Appeal NO: ABP 310466-21

**SOUTH DUBLIN COUNTY COUNCIL'S PLANNING AUTHORITY'S REPORT TO
AN BORD PLEANALA ON**

**Land Use Planning and Transportation Department
South Dublin County Council
County Hall
Tallaght, Dublin 24
Prepared by: Tracy McGibbon
Date of Report: 18th August 2021**

Figure 4.1

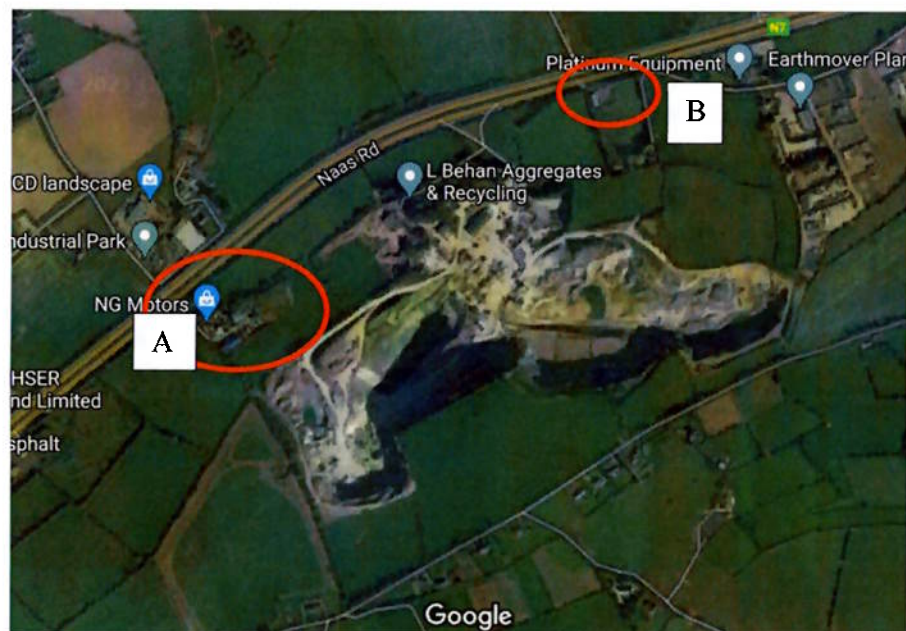
- 4.5.2 The Planning Authority also notes and would like to draw the Board's attention to commercial activities that are alleged to be taking place to the north and west of lands outlined in blue within the ownership of the applicant. **[Circled and labelled A on Figure 4.1]**. The lands take access from the Naas Road (N7). No planning history can be traced to these lands and a recommendation has been sent to South Dublin County Council's Enforcement department to investigate these works and commercial uses on rural zoned lands.

- 4.5.3 The Planning Authority also notes alleged unauthorised development, works and uses that have taken place on lands outlined in blue located to the north and east of the overall landholding. **[Circled and labelled B on Figure 4.1]** The site is located off the N7 (with an agricultural entrance in place). The development constructed on site appears to take access off the historic Naas Road, now cul-de-sac'd. No planning history can be traced to these lands and a recommendation has been sent to South Dublin County Council's Enforcement department to investigate these works and uses on rural zoned lands.

Figure 4.1

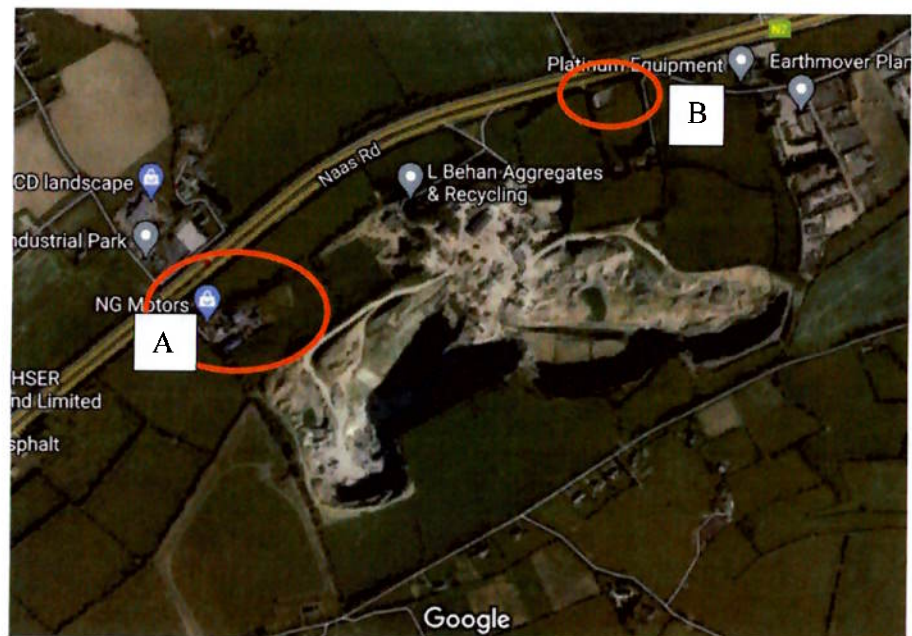
- 4.5.2** The Planning Authority also notes and would like to draw the Board's attention to commercial activities that are alleged to be taking place to the north and west of lands outlined in blue within the ownership of the applicant. **[Circled and labelled A on Figure 4.1]**. The lands take access from the Naas Road (N7). No planning history can be traced to these lands and a recommendation has been sent to South Dublin County Council's Enforcement department to investigate these works and commercial uses on rural zoned lands.

- 4.5.3** The Planning Authority also notes alleged unauthorised development, works and uses that have taken place on lands outlined in blue located to the north and east of the overall landholding. **[Circled and labelled B on Figure 4.1]** The site is located off the N7 (with an agricultural entrance in place). The development constructed on site appears to take access off the historic Naas Road, now cul-de-sac'd. No planning history can be traced to these lands and a recommendation has been sent to South Dublin County Council's Enforcement department to investigate these works and uses on rural zoned lands.
